BID ADDENDUM NO. 3

OWNER: EDGEMONT UNION FREE SCHOOL DISTRICT

PROJECT NAME: ADMINISTRATION BUILDING ADDITION,
SITE IMPROVEMENTS & RELATED WORK

DATE: March 21, 2025

SHEET SIZE 30"x42"	DRAWING NO.
SCALE AS NOTED	A825
DRAWN BY F & D	FILE NO. 24529.02

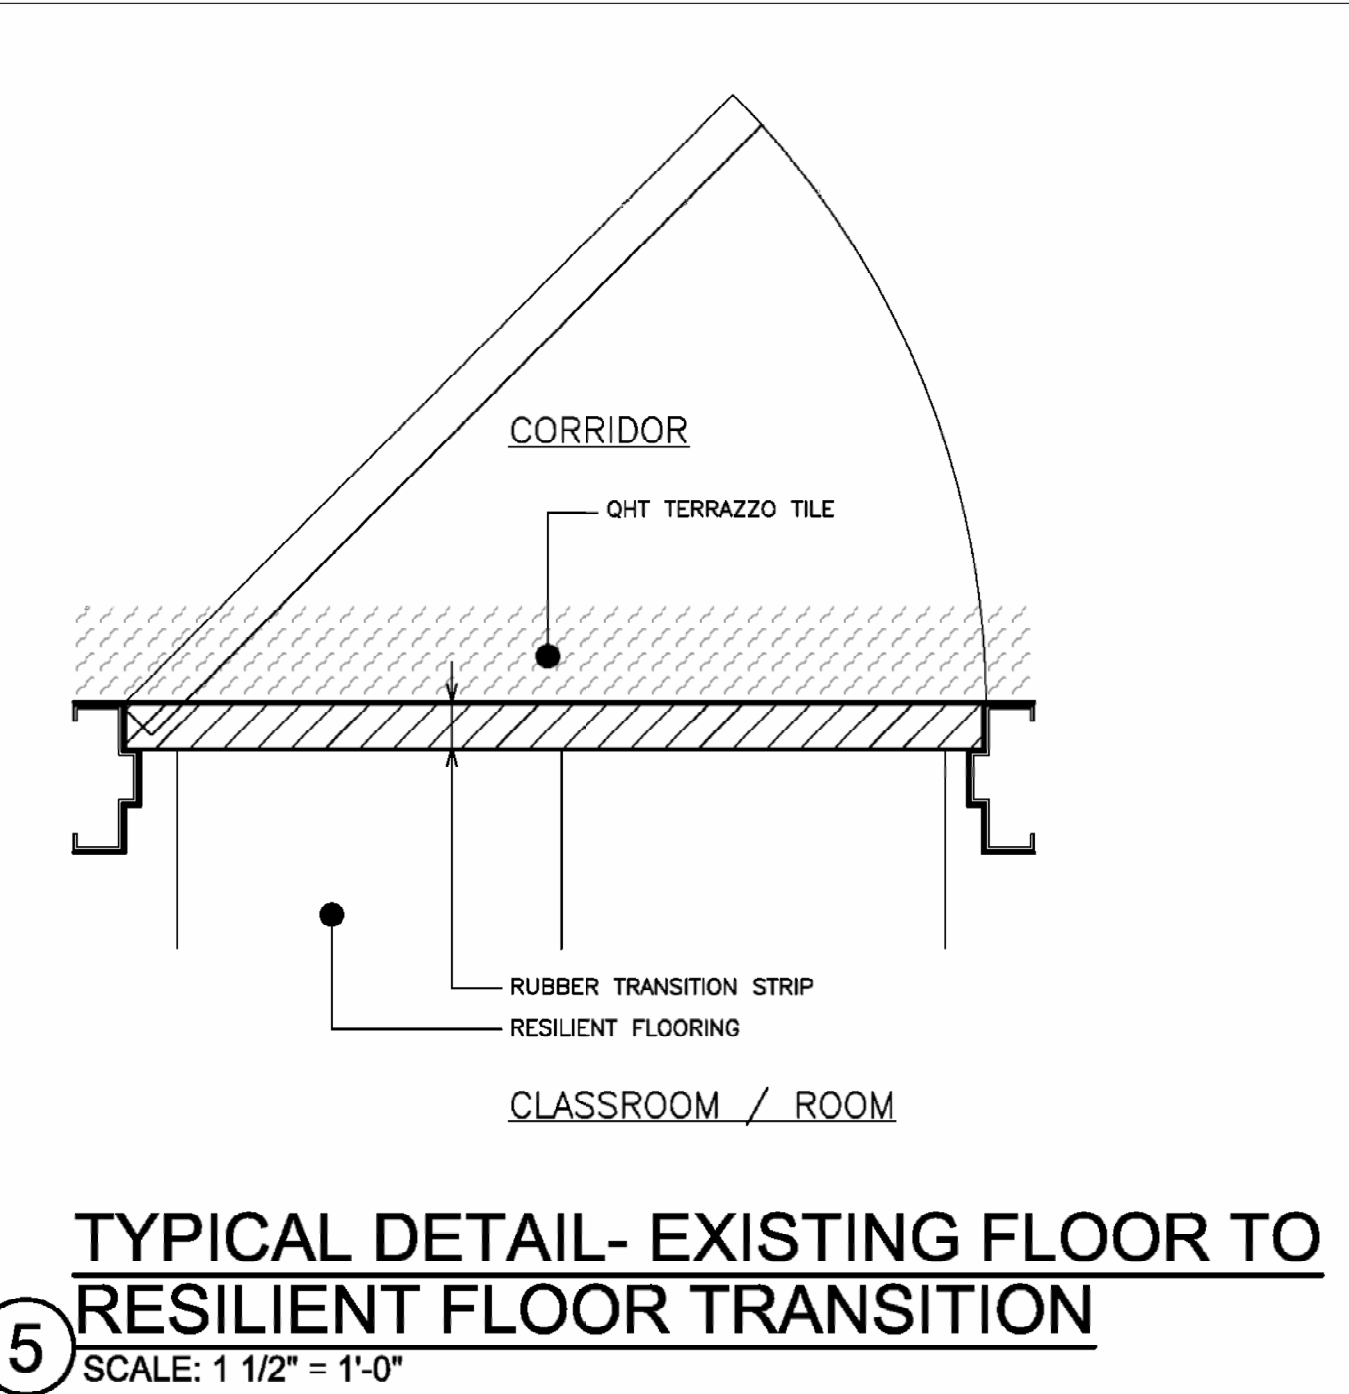
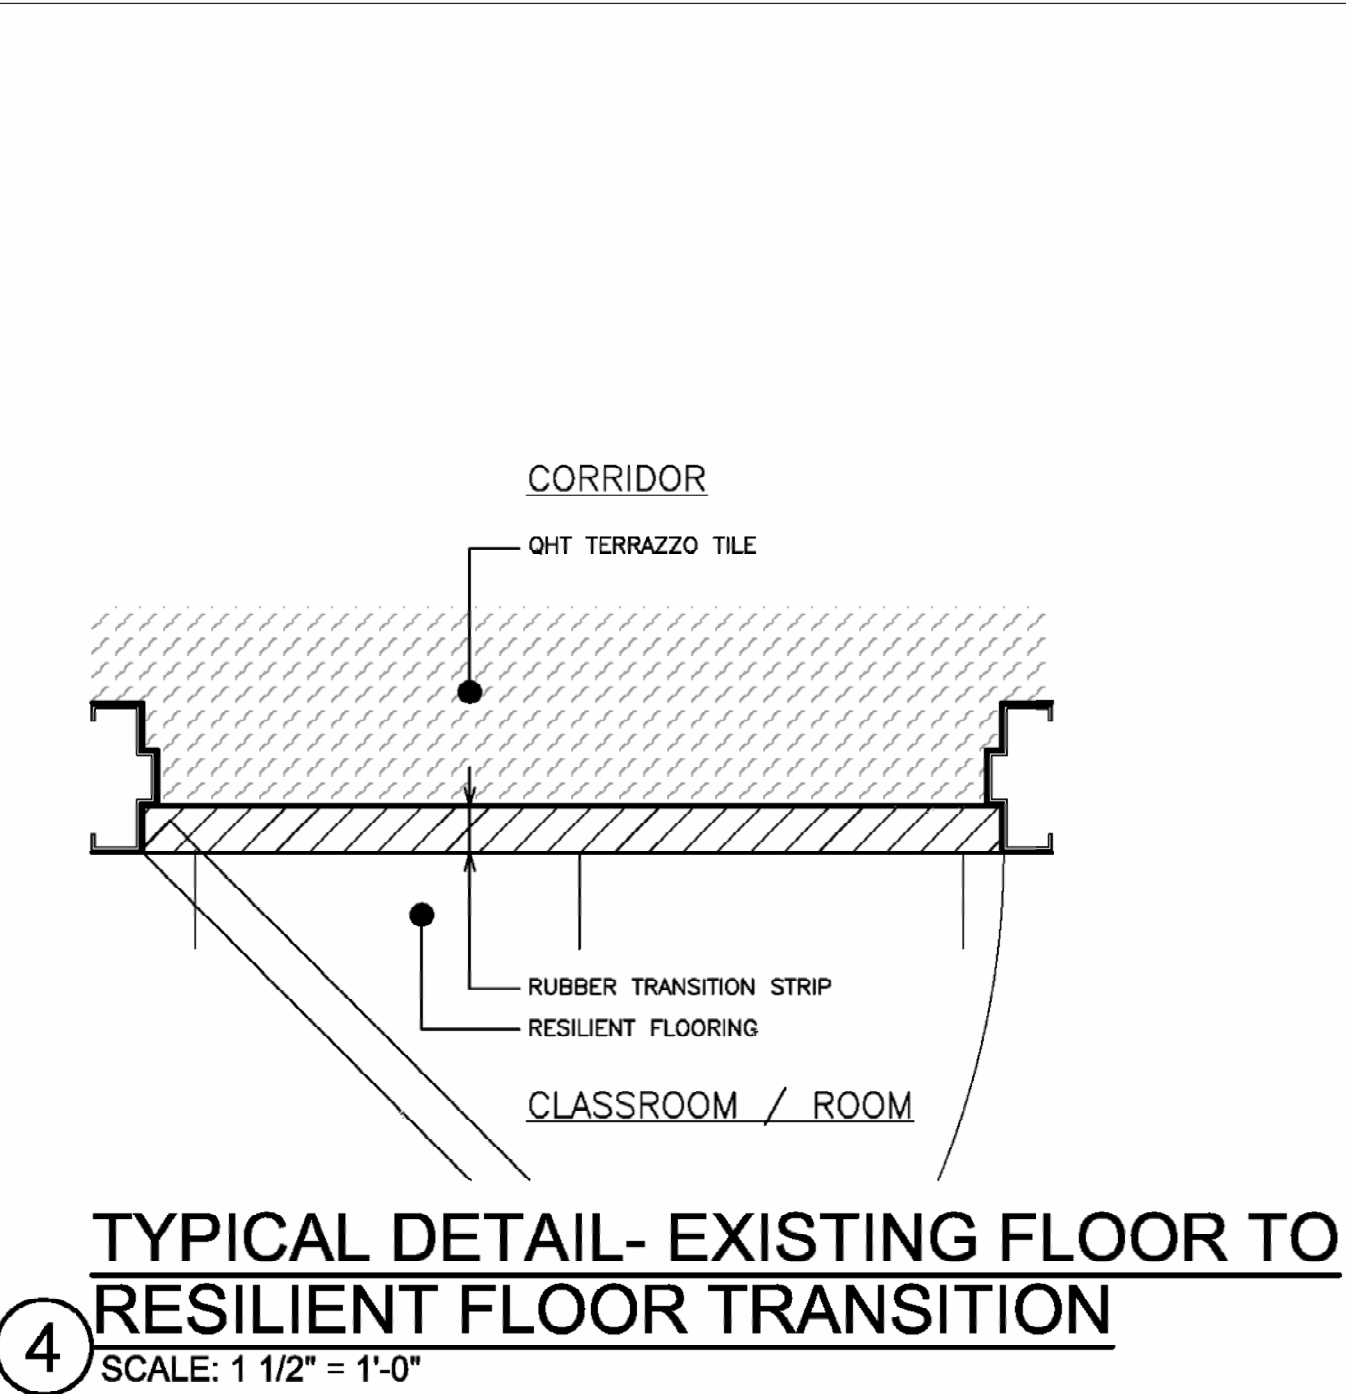
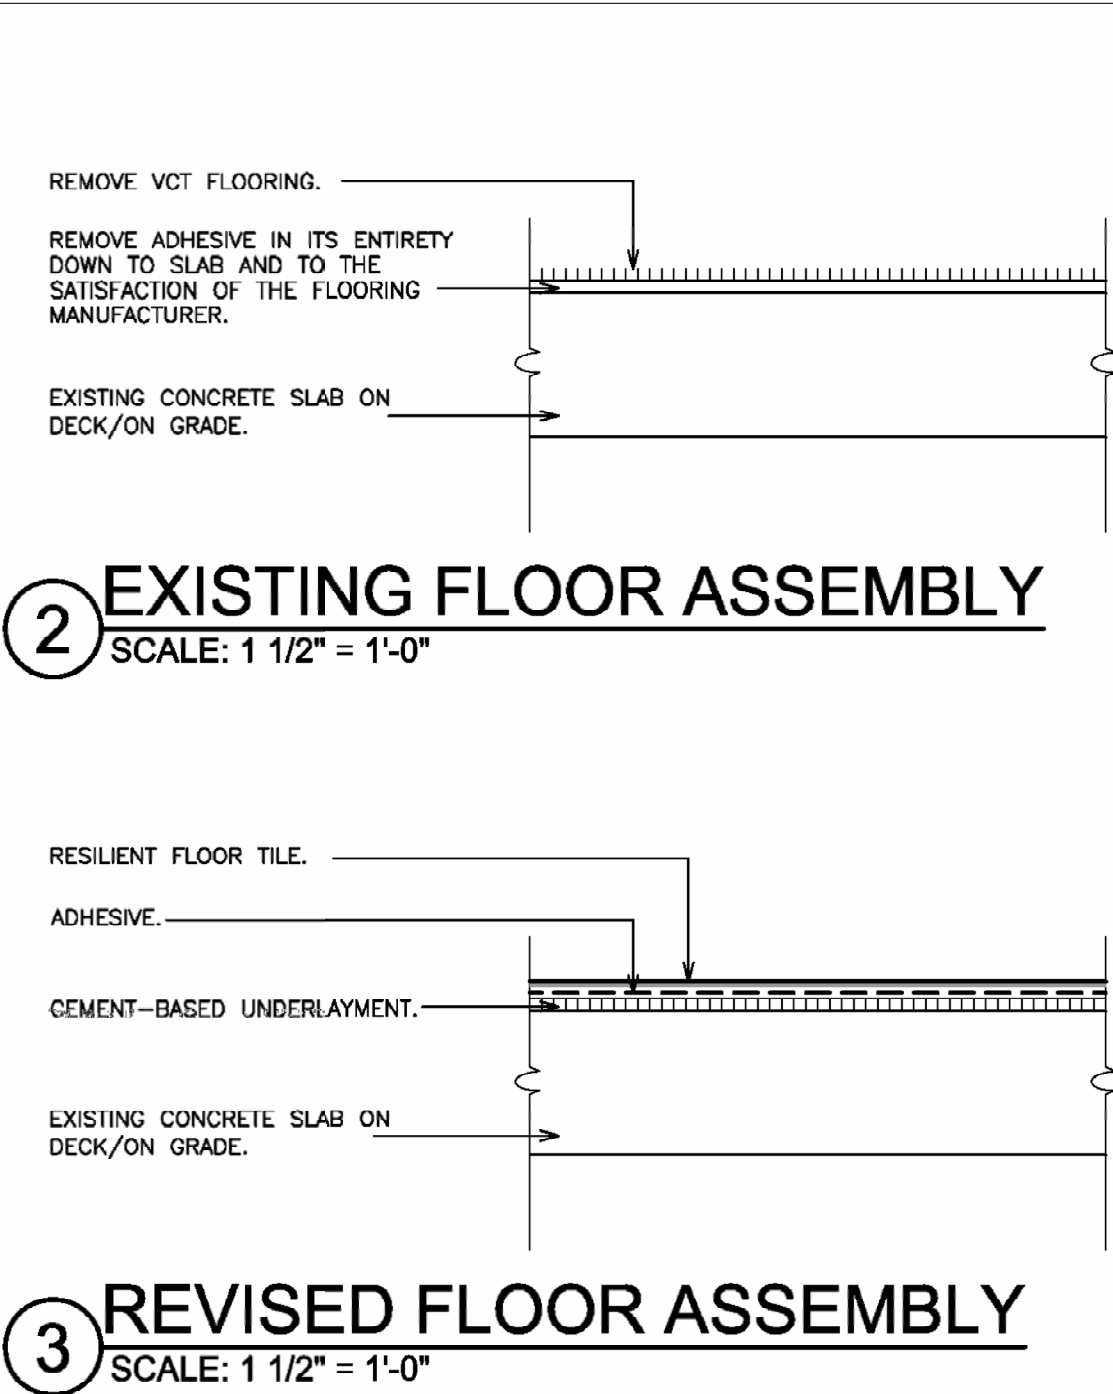
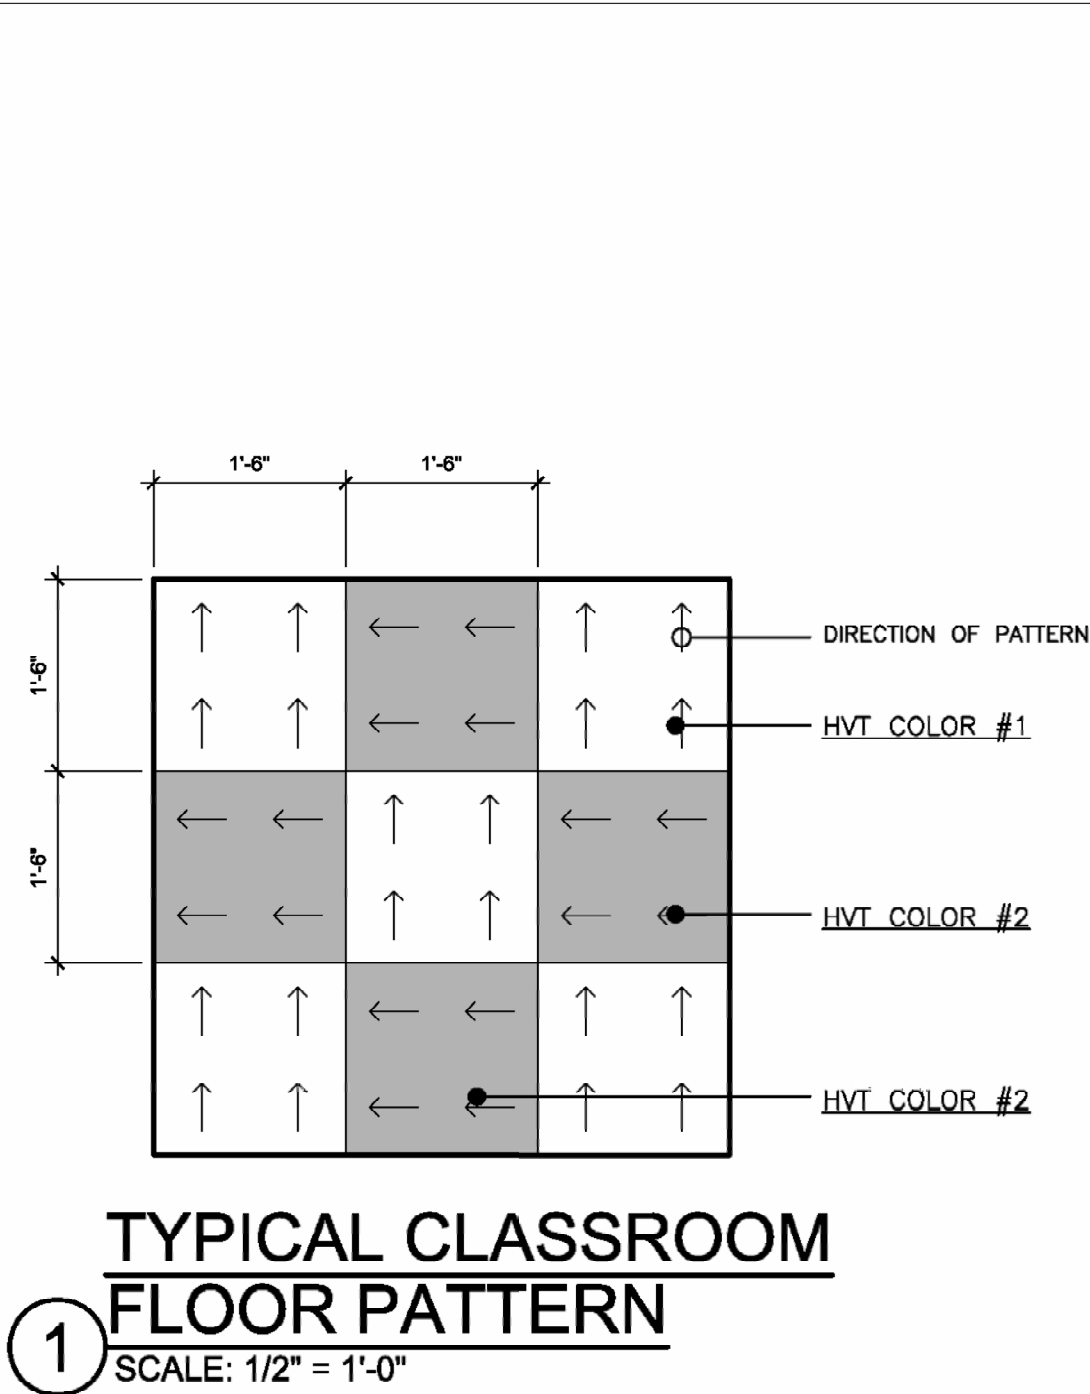
DRAWING A825 – FINISH LEGEND, FINISH SCHEDULE AND DETAILS

Finish Schedule, Line 12, Dry 320 **REVISE** ceiling material from ACT-3to P-3.

Finish Schedule, Line 16, Storage 350 **DELETE** ceiling material.

Finish Schedule, Line 18, Stair #1

4DELETE ceiling material.
